FRESHWATER BOAT RAMP IMPROVEMENTS

WATCHAUG POND, INDIAN LAKE, ECHO LAKE

P&D CONTRACT NUMBER 13-17

DEPARTMENT OF ENVIRONMENTAL MANAGEMENT
OFFICE OF WATER RESOURCES
FRESHWATER WETLANDS PROGRAM
APPROVED WITH CONDITIONS
AS SPECIFIED IN THE LETTER OF APPROVAL
DATED OCT 31 2017 FILE # 17-0200
NO CHANGES ALLOWED WITHOUT PRIOR APPROVAL
APPROVED PLANS MUST BE AT CONSTRUCTION SITE
Nancy L. Freeman

INDIAN LAKE
EXISTING CONDITIONS
AND DEMOLITION PLAN

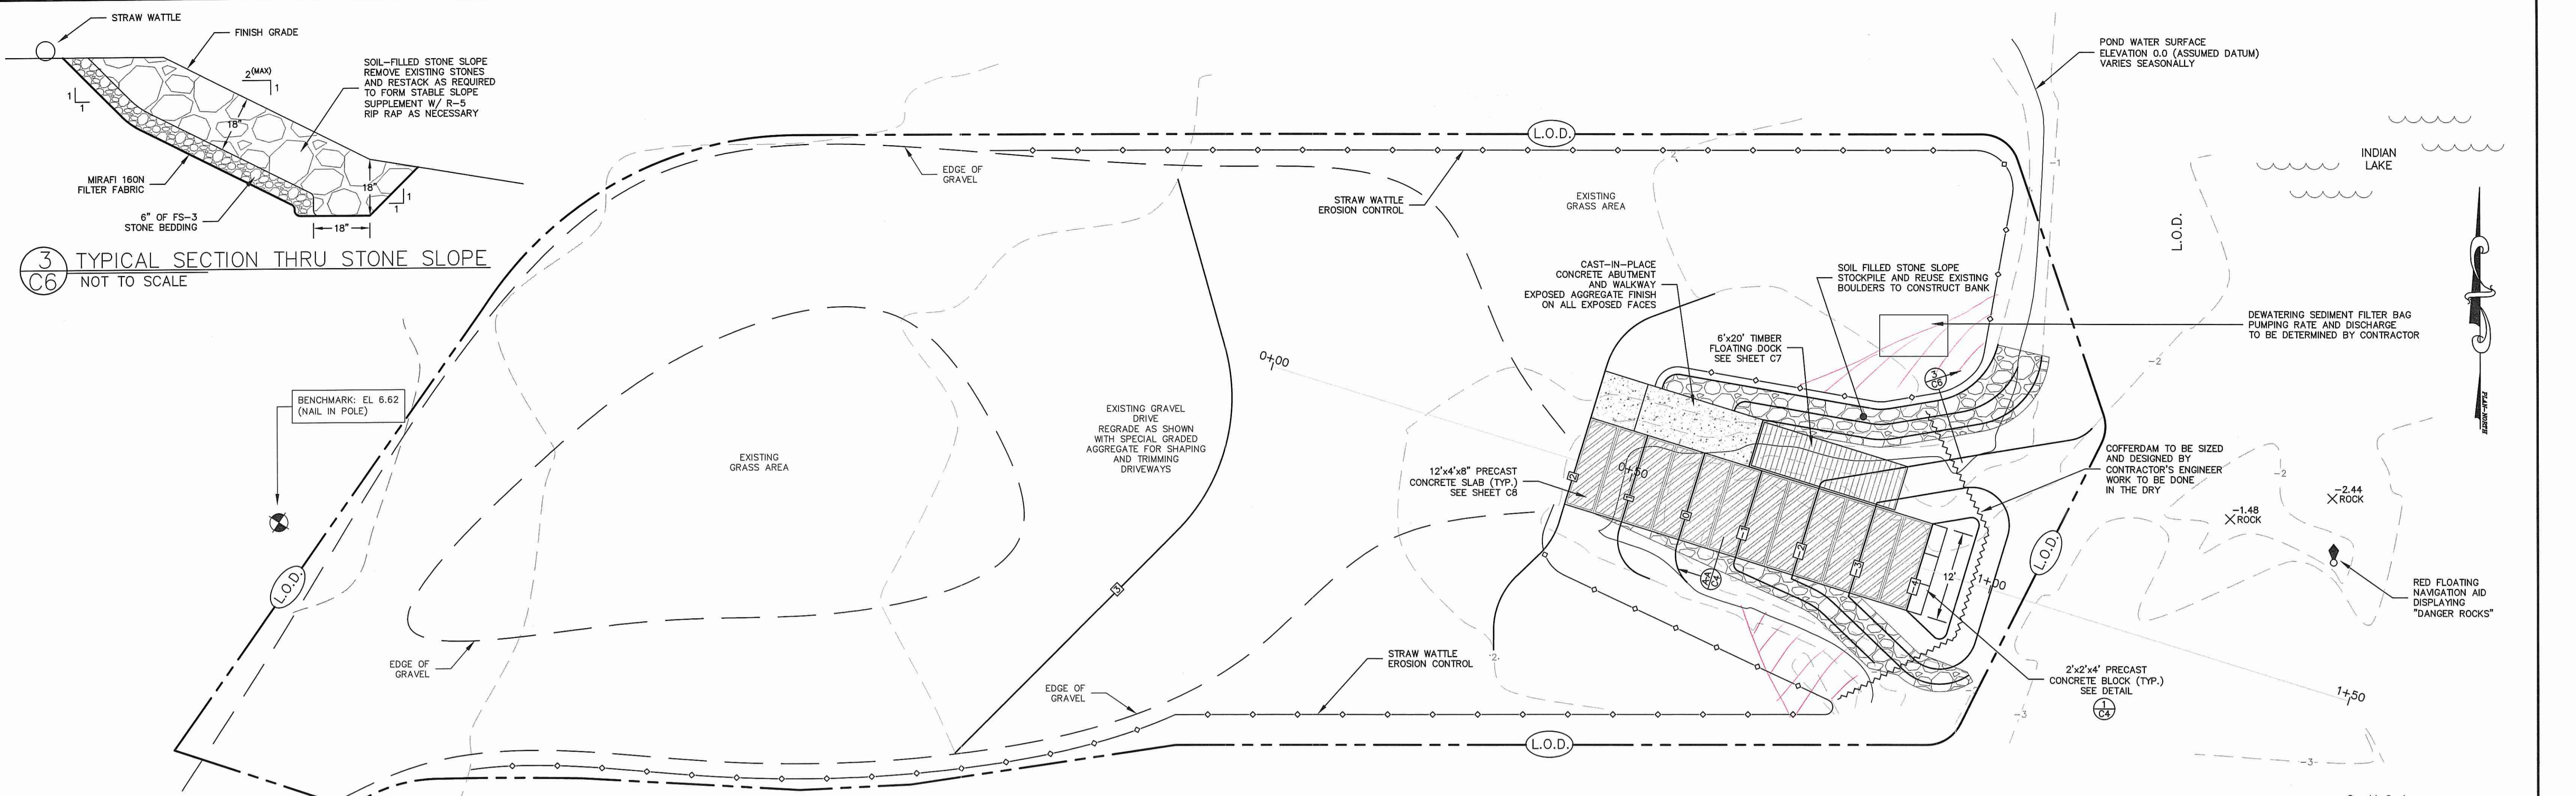
NOTE:
1. ALL EQUIPMENT SHALL REMAIN OUT OF THE WATERWAY FOR GRADING OPERATIONS OUTSIDE OF THE COFFERDAM. Grading operations are for stonework for shoreline stabilization - see Condition No. 16
Per R.I.D.E.H.'s Freshwater Wetlands Program:

A turbidity curtain is to be installed for all "in-water" work shown outside of the cofferdam per Condition No. 16

INDIAN LAKE
SITE PLAN
AND PROFILE

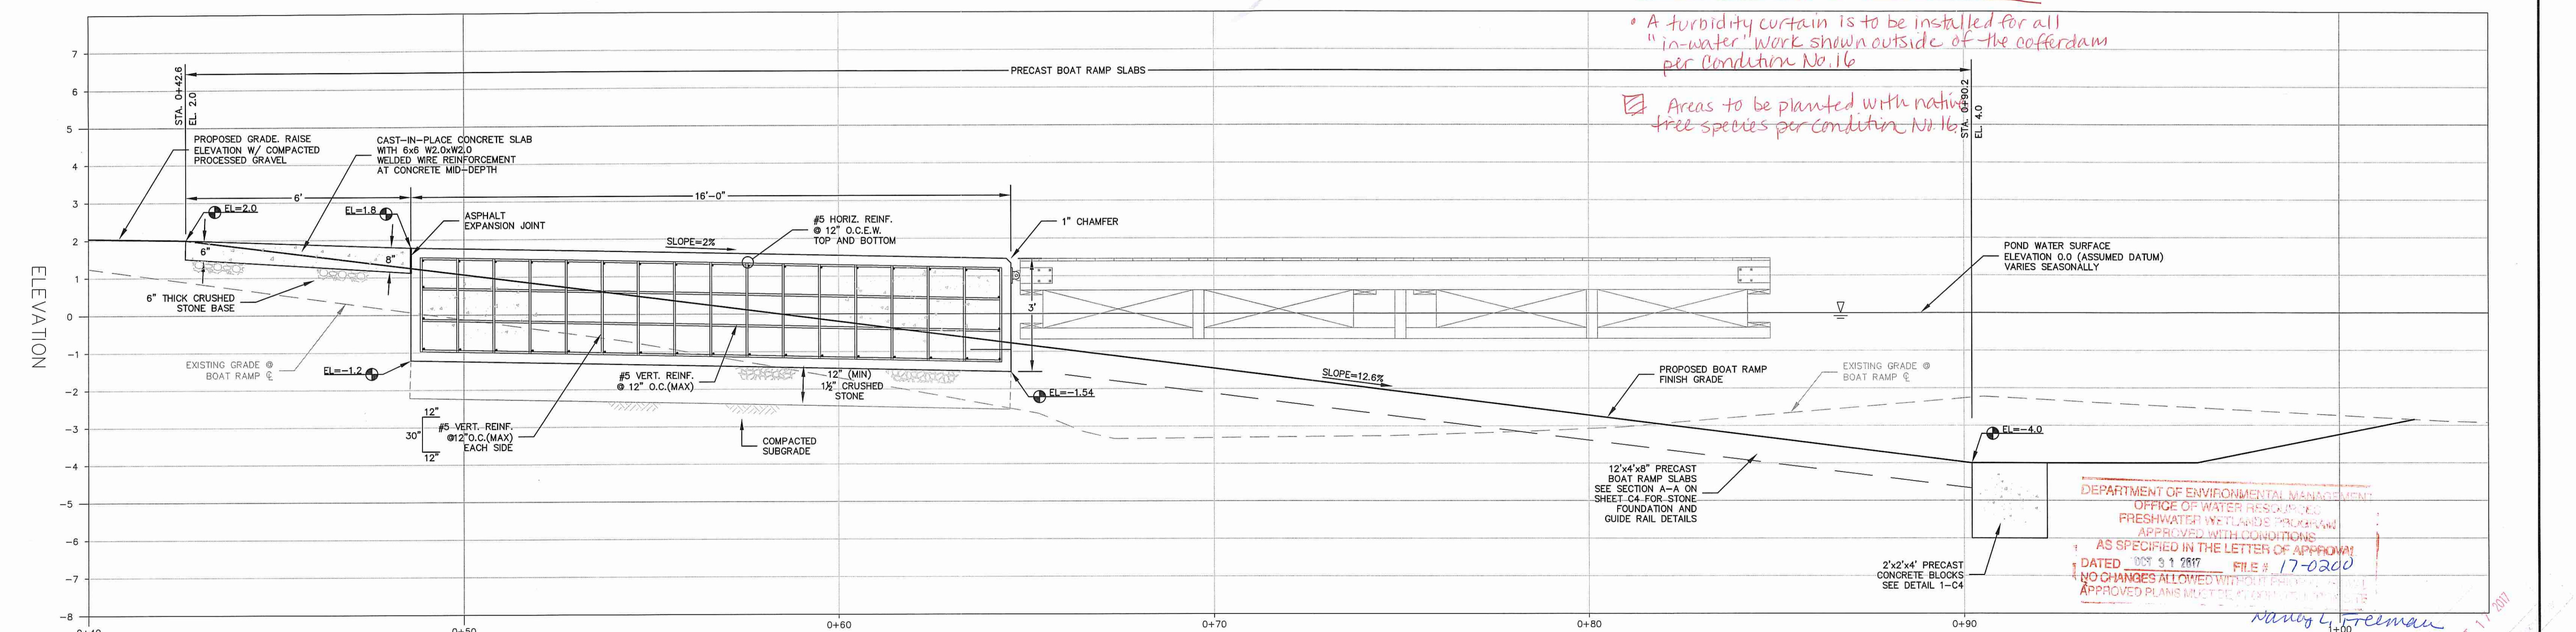
Areas to be planted with native tree species per Condition No. 16
